**Pacific Gas and
Electric Company™**

**RE: Potter Valley Hydroelectric Project, FERC No. 77-CA
2023 Flow Variance Request Due to Limited Storage Capacity**

**2023 Flow Variance Request Due to Limited Storage Capacity
Comment Response Matrix**

Figure 2. Lake Pillsbury daily storage forecast with variance conditions in effect (assuming July 1st start date). Storage forecast curves assume 2023 block water releases of 2,500 AF on 6/15 and Water Year 2024 block water release of 2,500 AF on 12/1.

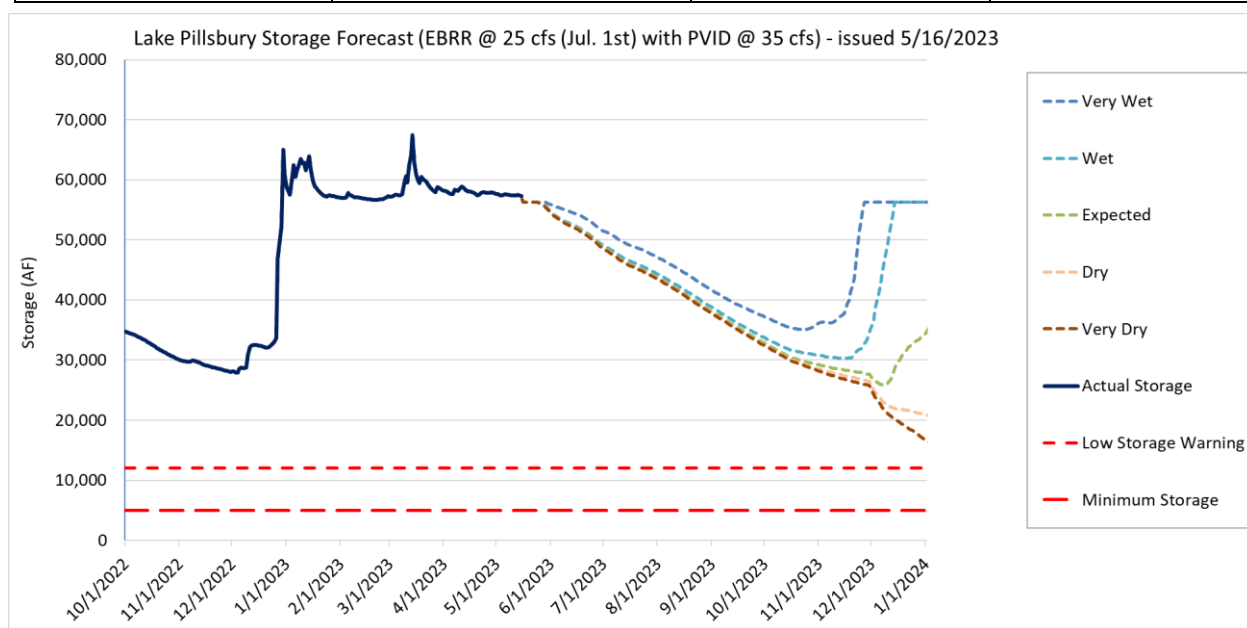
Commented [JAF9]: Should add a project variance storage figure based on max release under variance flow prescriptions, etc..

#	Location		Comment	Reviewer	Response
	Page	Section			
7	4	Proposed Variance	Should add a project variance storage figure based on max release under variance flow prescriptions, etc..	NMFS	Agreed, figure 2 added to page 5
8	4	Proposed Variance	So if the variance starts earlier than August 1, then we should modify the E-16 flows to indicate an earlier date than 8/1. Could do this in the title, or as another footnote. I think the "summer baseflow period (8/1-9/30) should be in the title due to the E-11 flow requirements, as before 8/1 is the ramp down period, and would require another column to the table for the period prior to 8/1 (again assuming the variance would start before 8/1). Text further down mentions mid-July...	RVIT; NMFS	Agreed, changed text in title of Table 2 from "August 1 – September 30", to "beginning of variance to September 30"
9	4	Proposed Variance	I guess no need to provide an estimated average? Currently 30 cfs in the spreadsheet	RVIT	The RPA does not set a minimum for Potter Valley Irrigation District (PVID) contract water deliveries (only sets a maximum), outside of winter frost protection and post-harvest irrigation periods, tied to FERC's October 14, 2009, license article 52 amendment. Accordingly, reductions to PVID contract water deliveries are at PG&E's discretion and outside the scope of this flow variance request. Therefore, the variance reductions will address EBRR flows, the minimum and maximum of which are dictated by the RPA.

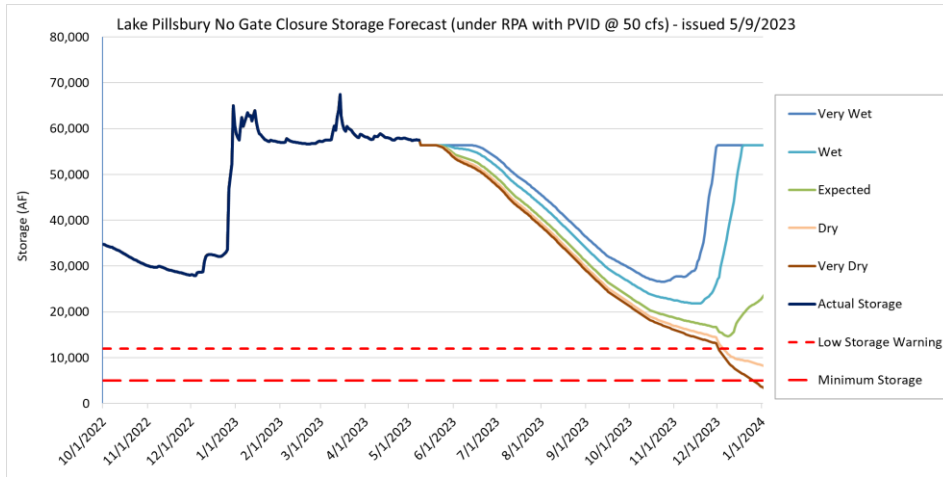
Commented [SM2]: This term should line up with the legend text below to avoid confusion, and to be consistent throughout document

Figure 2. Summary of median, average, and 10%-90% exceedance range of water temperatures at E-2 between May and September, using 2010-2022 data (excluding 2018 due to XXXX).

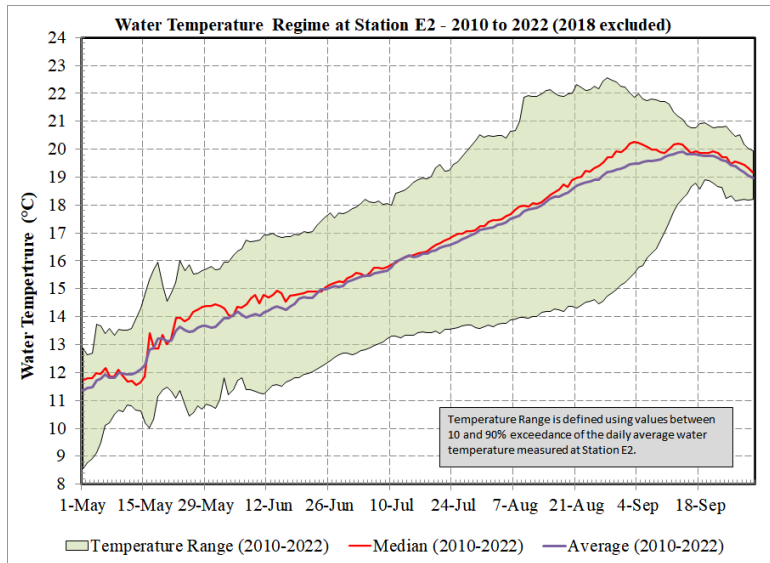
Commented [SM22]: As I mentioned yesterday, this could happen in early June based on the range shown on Figure 2. Added text to clarify

Under the adaptive flexible management approach, PG&E will monitor release water temperatures as measured at E-2 during the summer. When daily average water temperatures exceed 16 degrees Celsius averaged daily temperature (which is could occur around mid-July assuming median and average values – see Figure X2), PG&E will notify Agencies and begin meeting on a weekly basis to determine if diversions to the EBRR, as measured at E-16, should be reduced in support of minimizing withdrawals from the reservoir in order to stabilize better manage release temperatures.
